ECN/PCN No.: 4330

For Manufacturer			
Product Description: LOW ESR, LOW CL CERAMIC SMD CRYSTAL	Abracon Part Number / Part Series: ABM8W	<input type="checkbox"/> Documentation only <input checked="" type="checkbox"/> ECN <input type="checkbox"/> EOL	<input checked="" type="checkbox"/> Series <input type="checkbox"/> Part Number
Affected Revision: B	New Revision: C	Application:	<input type="checkbox"/> Safety <input checked="" type="checkbox"/> Non-Safety

Mechanical dimensions:

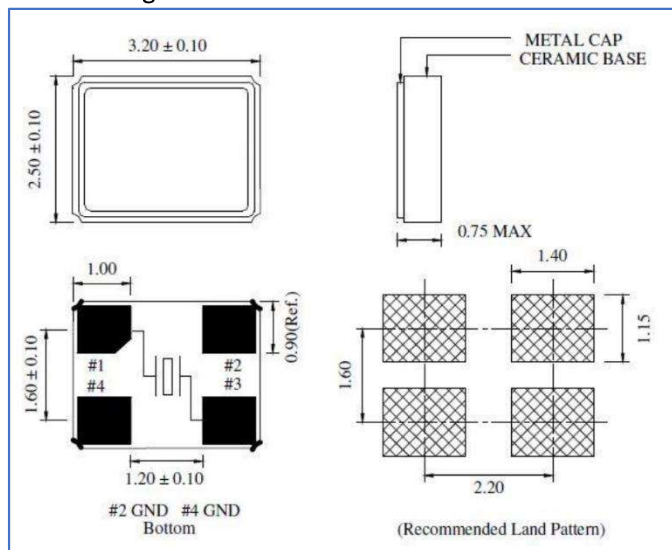
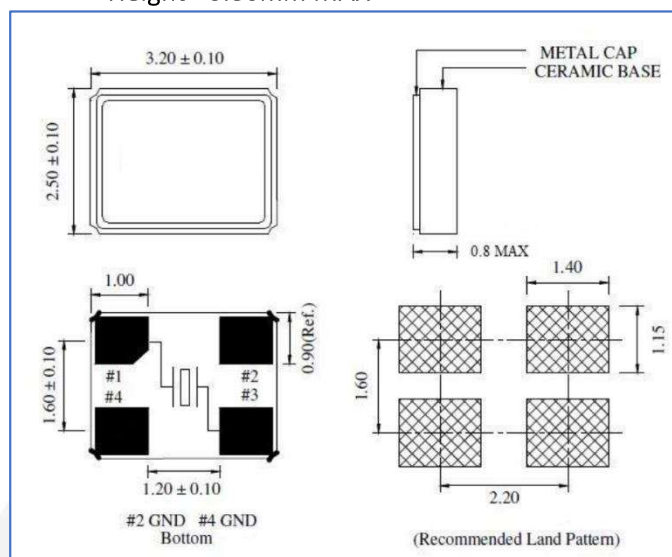
- Height= 0.75mm MAX

- Height= 0.80mm MAX

Abracon introduced additional manufacturing sources to ensure product availability and to be in a better position to meet long term customer demand. Updated mechanical dimensions to reflect the product produced by all manufacturing sources.

Change Plan		
Effective Date: 12/01/2022	Additional Remarks: N/A	
Change Declaration: The package mechanical dimension revision do not impact the recommended landing pattern nor the electrical performance of the device.		
Issued Date: 12/01/2022	Issued By:	Issued Department:
Approval:	Approval:	Approval:
For Abracon EOL only		
Last Time Buy (if applicable): N/A	Alternate Part Number / Part Series: N/A	
Additional Approval: N/A	Additional Approval: N/A	Additional Approval: N/A
Customer Approval (If Applicable)		
Qualification Status: <div style="text-align: center;"> <input type="checkbox"/> Approved <input type="checkbox"/> Not accepted </div> <i>Note: It is considered approved if there is no feedback from the customer 1 month after ECN/PCN is released.</i>		
Customer Part Number:	Customer Project:	
Company Name:	Company Representative:	Representative Signature:
Customer Remarks:
